Application for Waiver from Construction Standards for Public Water Systems

Water System Name Portland Water Bureau PWS ID 00657
Project or Facility Bull Run Filtration Finished Water Pipelines County Multnomah
Need for waiver identified: Water System Survey Date of Survey
 Plan Review # Exempt

Construction standard requested to be waived: OAR 333-061-0050 (9)(b) water sewer separation

Waiver ID 489-2024

SHEET NO: FWP-C-2100

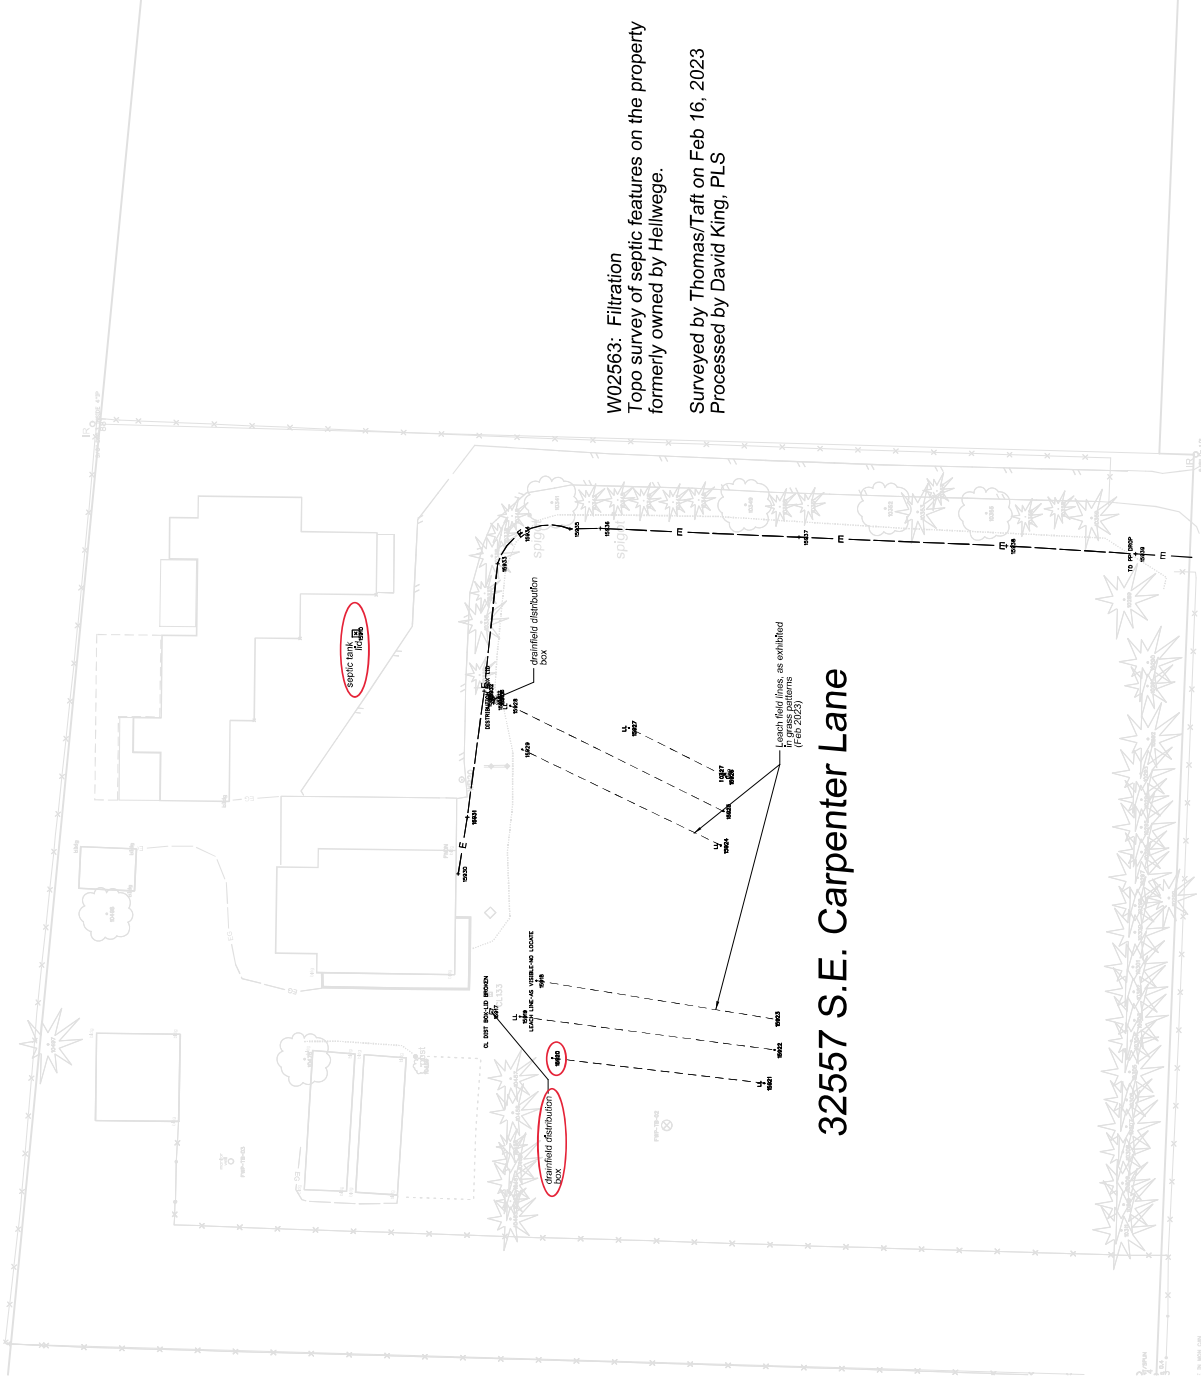
Comparing the existing systems with the likely design for the new septic tank drain line, the drain line is very likely to be above 700' elevation at the crossing.
Safe estimate is a 21' vertical clearance at the crossing.

New casing for septic line.
New residential septic line to new drainfield.

This ADU and its associated septic system with drainfield will be demolished/ decommissioned due to the proximity with the new finished water conduit.

This septic system is proposed. The drain field is located on the opposite side of the conduit from the house therefore a crossing is necessary.

Future easement
This septic system will be decommissioned because the leach field is located over the new finished water conduit.
